3.0 RESPONSE TO COMMENTS

Chapter 3 includes responses to the three (3) comment letters received (Letters included in Appendix A) on the Draft SEIR during the public review period. The following comment letters were received during the public review period for the Draft SEIR:

Letter 2: Adams Broadwell Joseph & Cardozo (on behalf of Citizens for Responsible Industry) – September 3, 2019

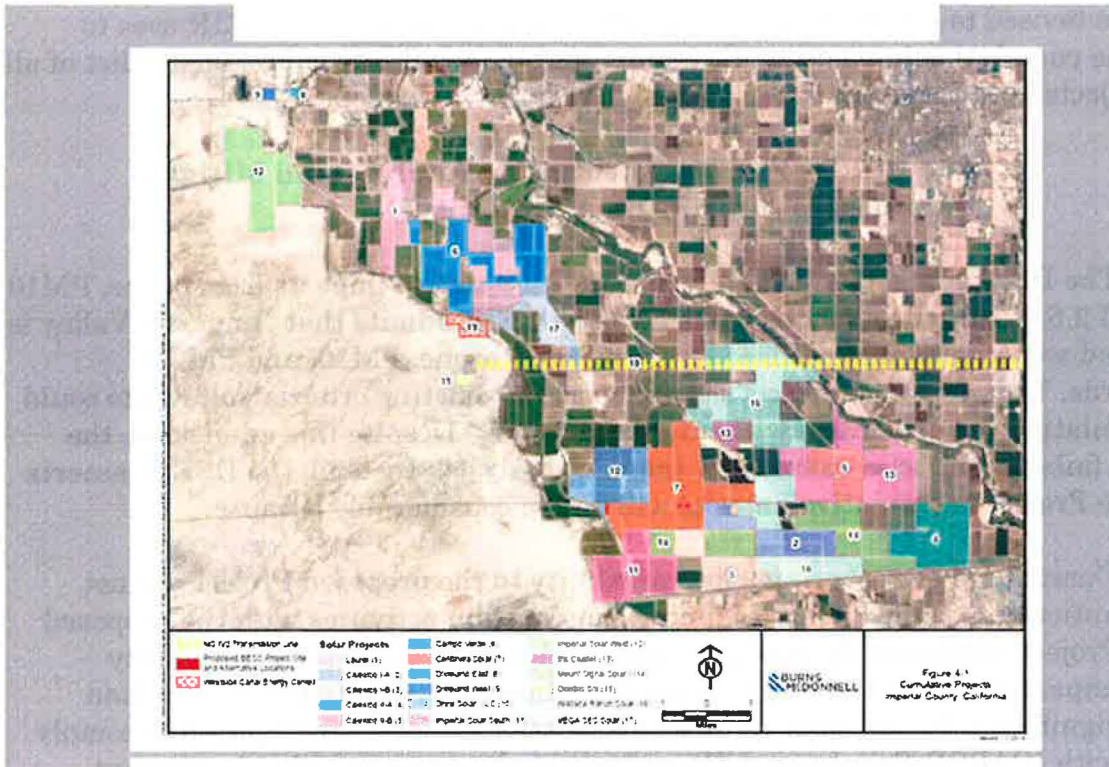
But Table 4-1 omits multiple similar projects located within the SSAB without explanation, including multiple solar plants located in and around the city of Calipatria.¹⁵⁰ Thus, while the DSEIR claims to use the SSAB as the geographical

The commenter referenced a specific project, the Heber Solar Project, as well as *multiple solar plants located in and around the City of Calipatria* while also referencing a source (<https://www.seia.org/research-resources/major-solar-projects-list>) for these projects. The projects referenced by the commenter in the website above represent operational solar sites; as such, the short-term construction related impacts to air quality have already occurred.
